TENNESSEE VALLEY AUTHORITY  
SEQUOYAH PLANT (SQN)  
UNITS 1 AND 2

PROPOSED TECHNICAL SPECIFICATION (TS) CHANGE  
MARKED PAGES

TENNESSEE VALLEY AUTHORITY  
SEQUOYAH NUCLEAR PLANT (SQN)  
UNITS 1 AND 2

PROPOSED TECHNICAL SPECIFICATION (TS) CHANGE  
REVISED PAGES

FIGURE 3.4-1 a  
DOSE EQUIVALENT I-131 Primary Coolant Specific Activity Limit Versus  
Percent of RATED THERMAL POWER with the Primary Coolant Specific  
Activity > 1.0  $\mu\text{Ci/gram}$  Dose Equivalent I-131 for Cycle 10 Operation

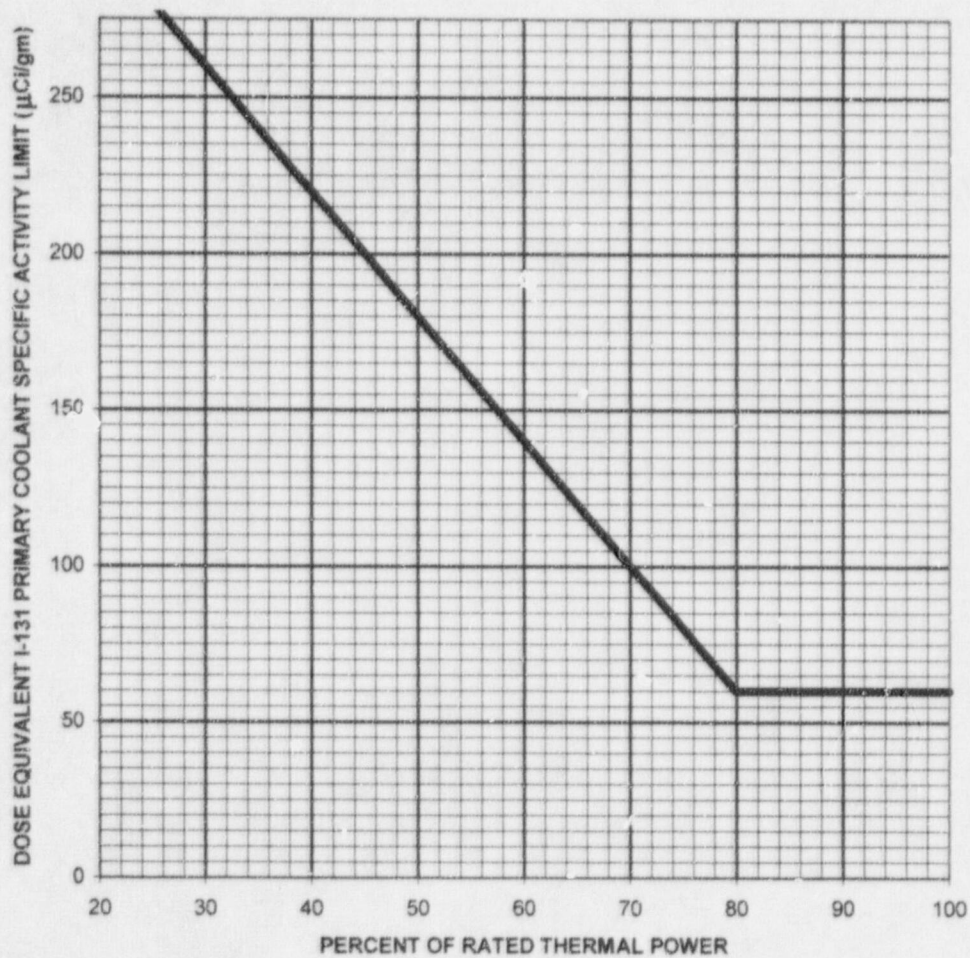
\* For Unit 2 Cycle 10 operation, refer to Figure 3.4-1a.

Insert  
(Figure 3.4-1a)

\* For Unit 2 Cycle 10 operation, refer to Figure 3.4-1a.

\*\* For Unit 2 Cycle 10 operation, a DOSE EQUIVALENT I-131 less than or equal to 1.0 microcurie per gram shall be maintained.
